# FINAL PLAT

## BAY RIDGE ADDITION

RE: S/D 98-109 -- Final Plat of BAY RIDGE ADDITION

STAFF COMMENTS:

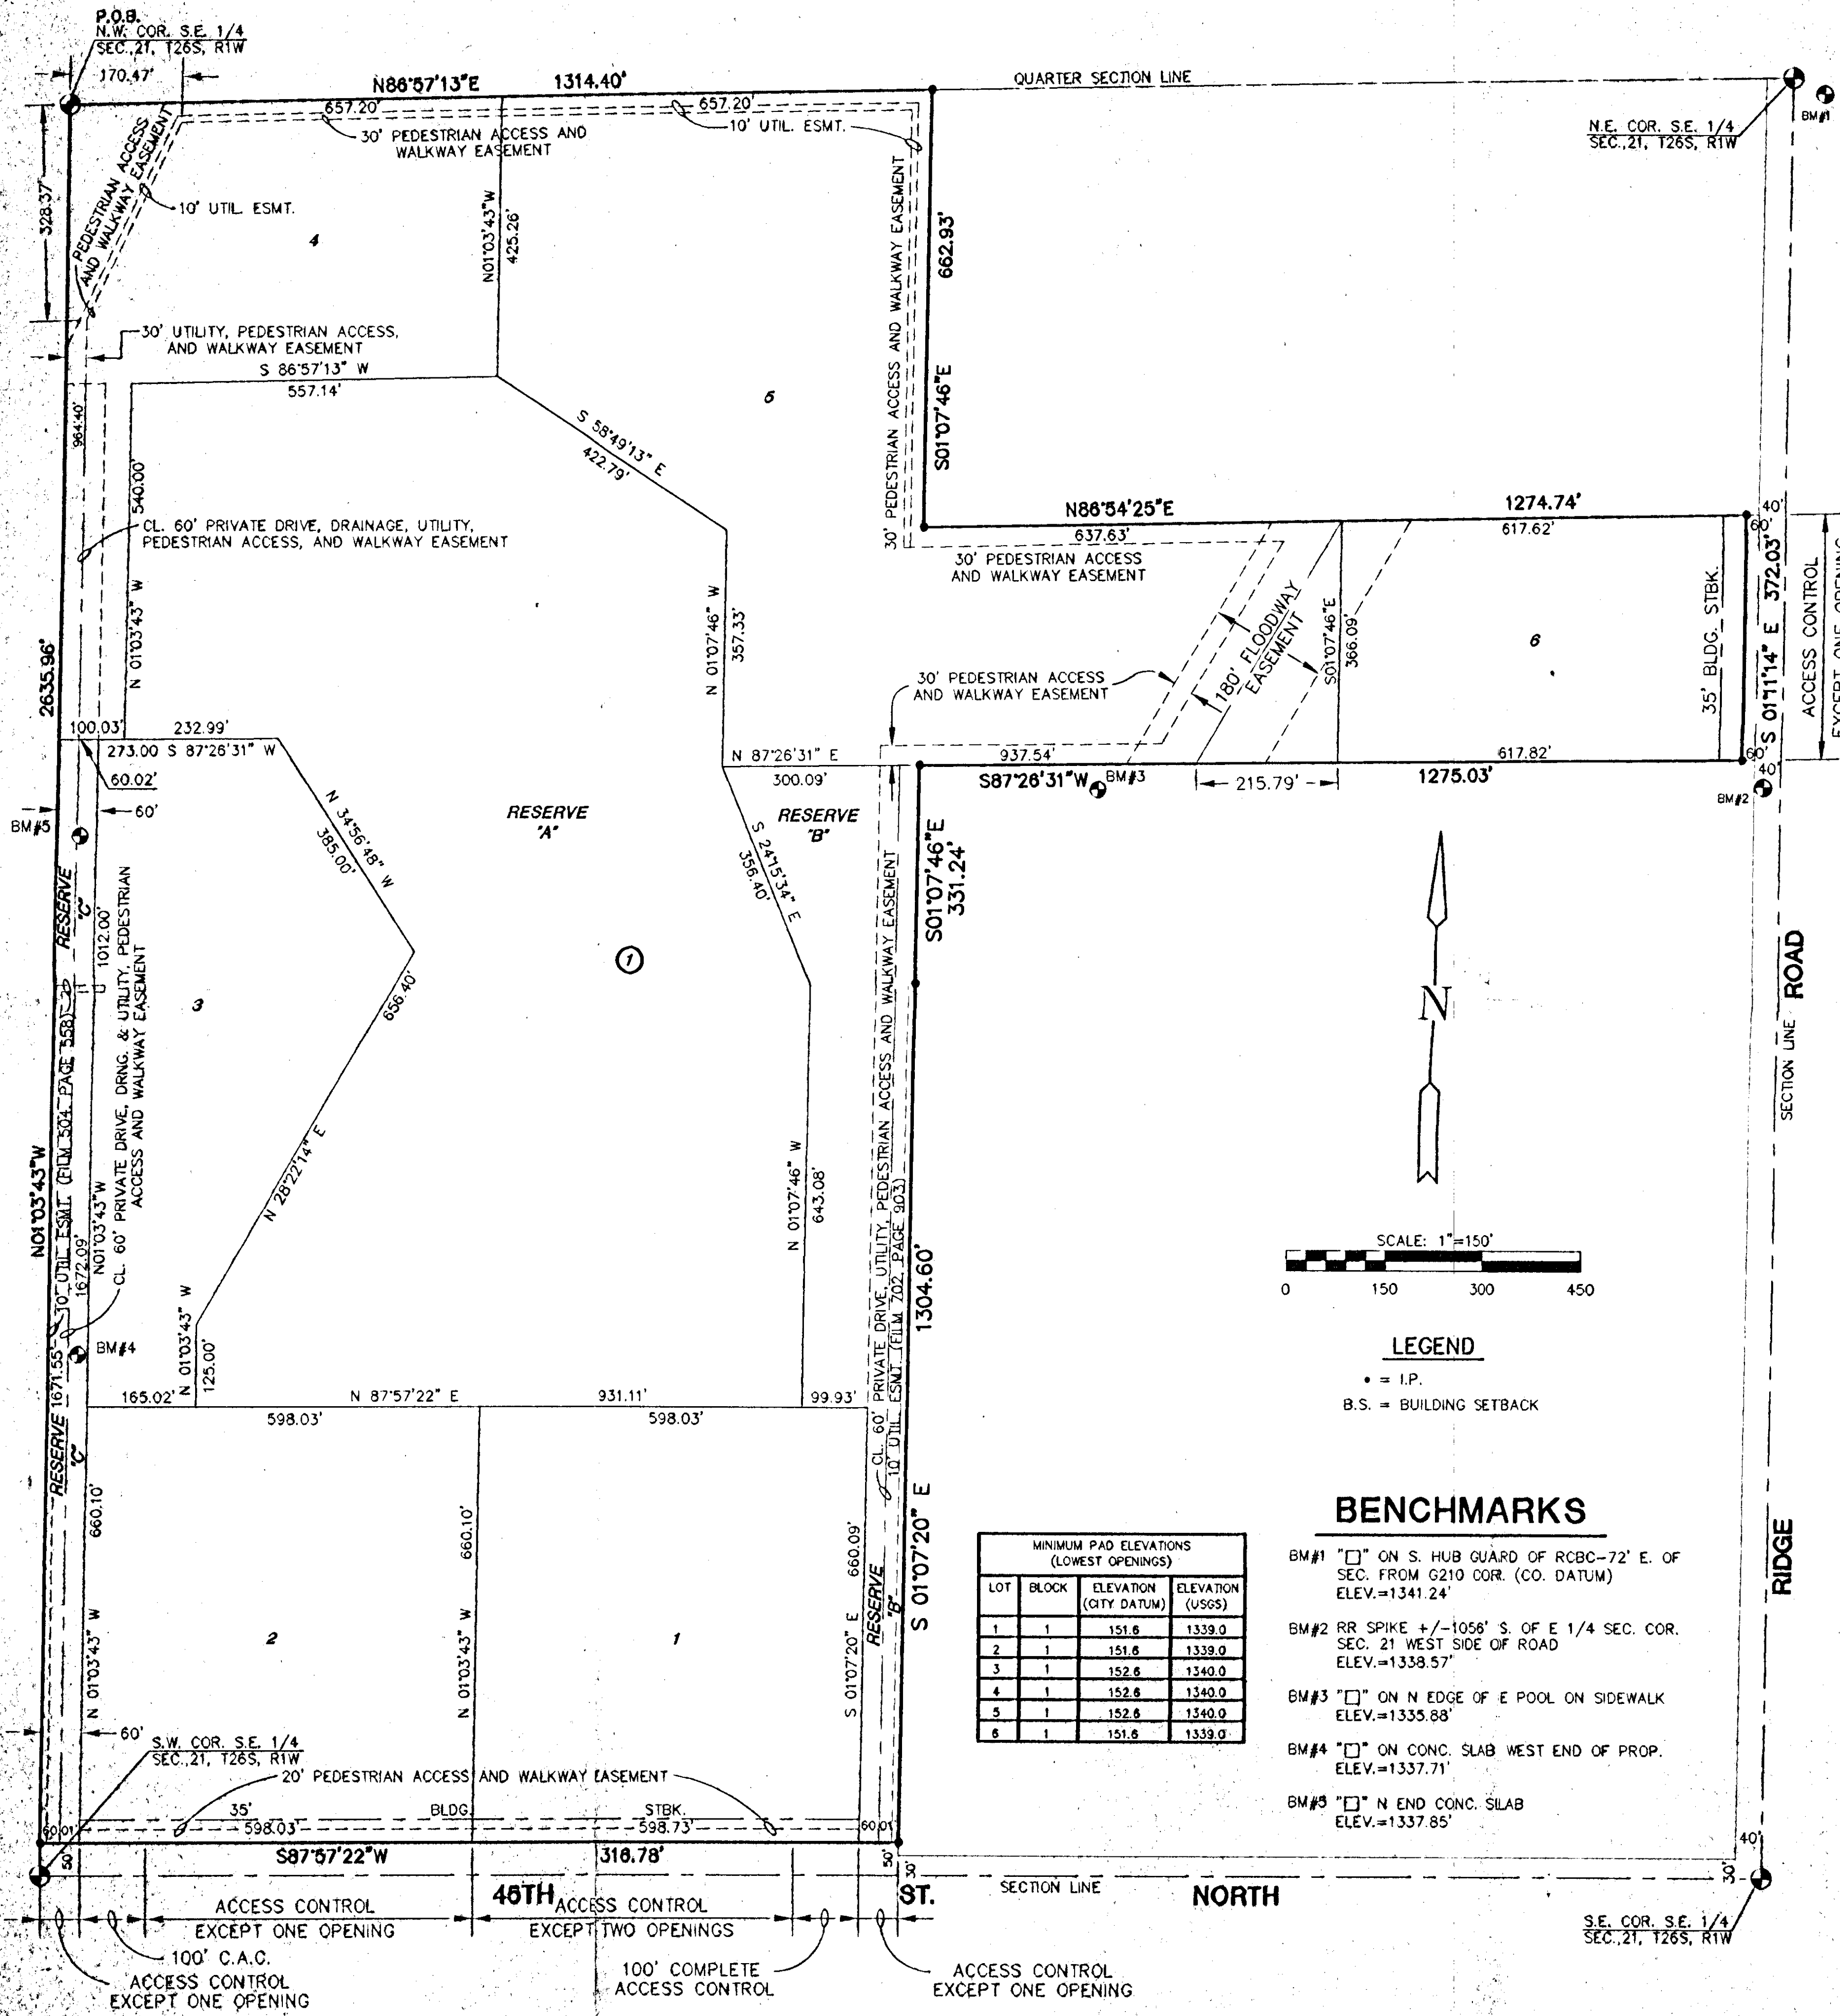
- C. County Engineering needs to comment on the status of the applicant's drainage plan. The drainage plan is approved. Revised minimum pads need to be platted. Lot 5 needs to be relocated outside of the floodplain.

- ✓ E. County Engineering needs to comment on the access controls. The plat denotes one access opening along Ridge and six openings along 45th St. North. County Engineering has approved one opening for lot 2 and two openings for lot 1 along 45th St. North. 100 feet of complete access control is required adjoining each private street. 60 feet of half street right-of-way is required along Ridge Road.

- F. The Register of Deeds shall be revised to read, "Bill Meek".

- G. County Fire shall comment on the acceptability of the private streets. The plat denotes a 2,200-ft private street from 45th St. North to Lot 4 and a 1,600-ft private street from 45th St. North to Lot 6. County Fire requests turnarounds for each private street.

- I. On the final tracing, the two tie points at the south line of the plat need to be revised to reference the southwest and southeast corners of the quarter section.
